# Duquesne Light Company

Reference: Beaver Valley Power Station, Unit No. 2  
Docket No. 50-412, License No. NPF-73  
ISI Program: Revision 3 to Relief Request BV2-C6.10-1

RELIEF REQUEST NO. EV2-C6.10-1, Rev. 3

Recirculation Spray Pump (2RSS\*P21A) - Pump Casing Welds (see list below).

BVPS Unit 2  
Recirculation Spray Pump  
Welds 17 and 18 (Typical for Welds 9 and 10)  
Preservice Nov. 1986

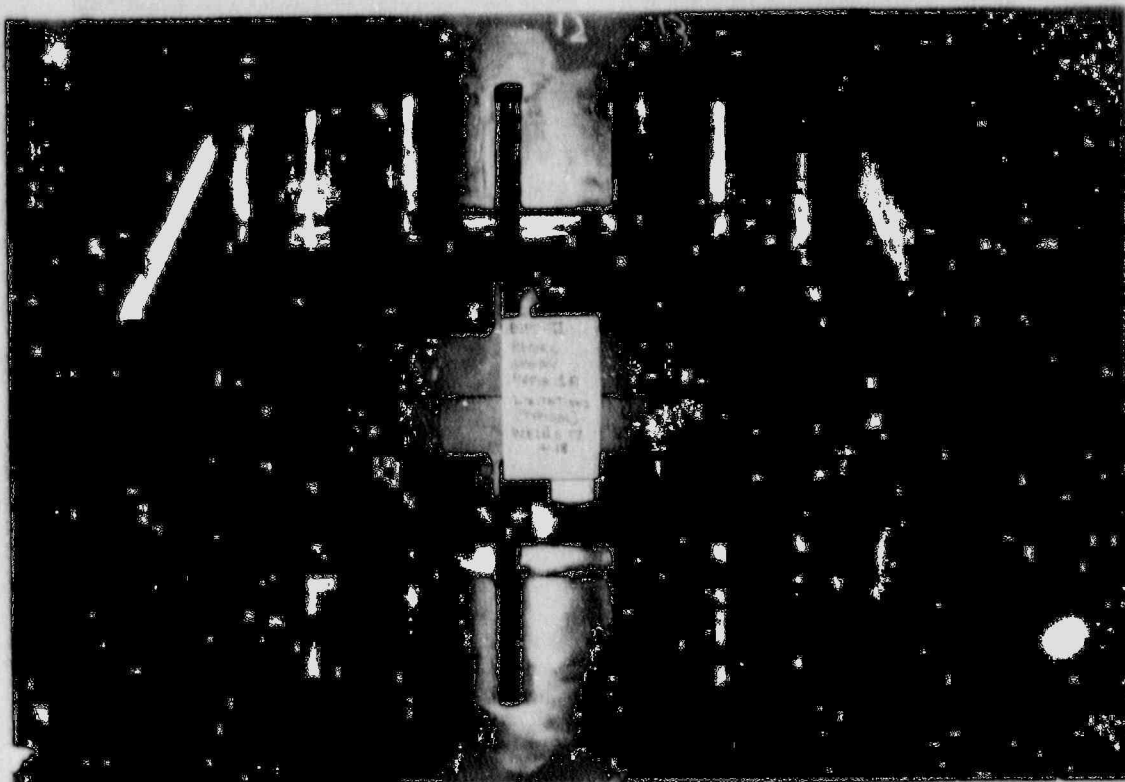
The revised relief request reformats our request and deletes two welds which have since been determined to be accessible for surface examination. Additionally, a photograph of two of the welds contained in the request has been included to illustrate the interferences which exist to inhibit 100% surface examination.

The specific limitation, along with the percentage of the required surface area of each weld that can be examined is listed below.

<u>Weld No.</u>	<u>Percent Examined</u>	<u>Interfering Condition</u>
2RSS*P21A-W-9	70%	Gussets
2RSS*P21A-W-10	70%	Gussets
2RSS*P21A-W-11	0%	Inaccessible due to concrete floor sleeve.
2RSS*P21A-W-12	0%	Inaccessible due to concrete floor sleeve.
2RSS*P21A-W-13	0%	Inaccessible due to concrete floor sleeve.
2RSS*P21A-W-15	0%	Inaccessible due to concrete floor sleeve.
2RSS*P21A-W-16	20%	Weld continues into floor sleeve.
2RSS*P21A-W-17	70%	Gussets
2RSS*P21A-W-18	70%	Gussets
2RSS*P21A-W-21	0%	Inaccessible due to being in pump sump.
2RSS*P21A-W-23	0%	Inaccessible due to being in pump sump.
2RSS*P21A-W-24	0%	Inaccessible due to being in pump sump.
2RSS*P21A-W-25	0%	Inaccessible due to being in pump sump.

Perform surface examination on accessible area to the maximum extent practical. Perform VT-2 during each inspection period.
